January 14, 1994

From: William H. Snyder, MD-81
Chief, Fluid Modeling Branch

Subject: Review of CPP Report on Wind Tunnel Modeling of Cape Industries Facility of
Wilmington, NC

Cape Industries
93-0955
Equivalent Building Height Tests
Wind Direction 0 Deg.

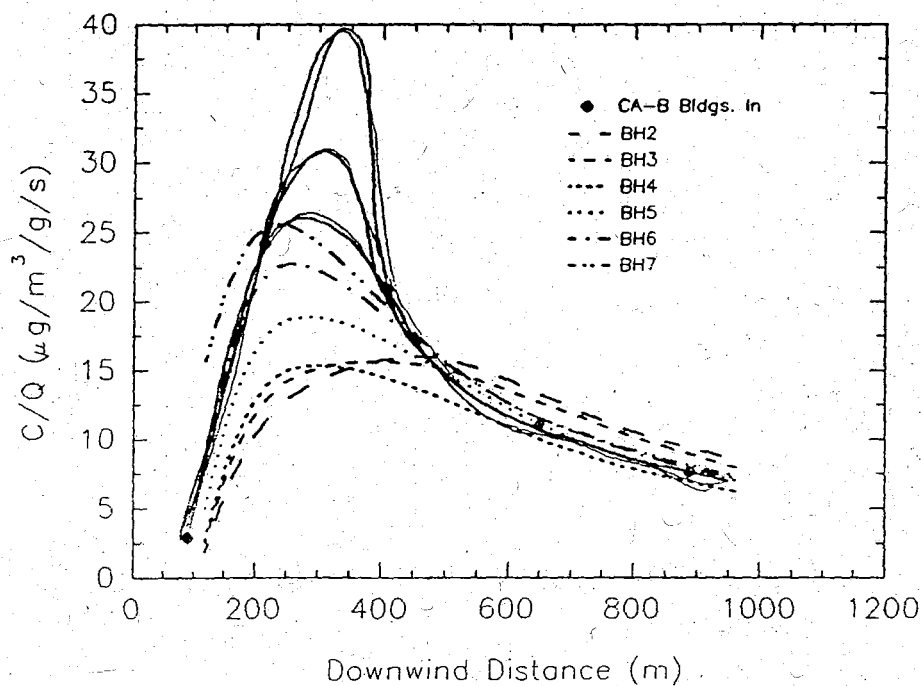
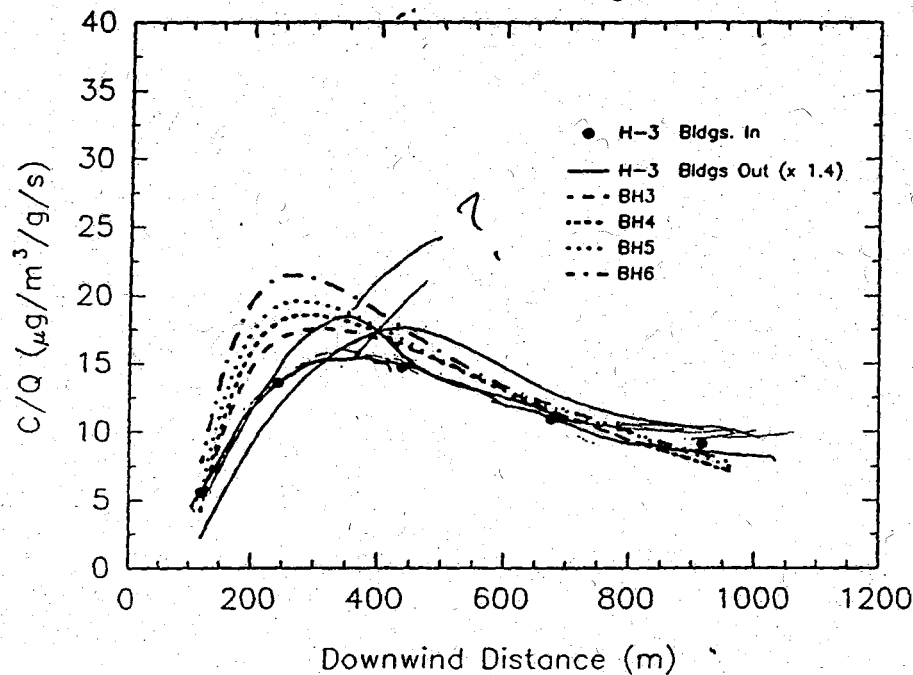
8. I believe the location of the single solid structure is immediately upwind of the stack in question, with broad side perpendicular to the wind -- these solid buildings are not shown in the photographs. In fact, these solid buildings were never placed within the plant complex. They were, instead, placed within an area with enhanced roughness, presumably matching the roughness of the plant complex (see Figure 5, page 37).
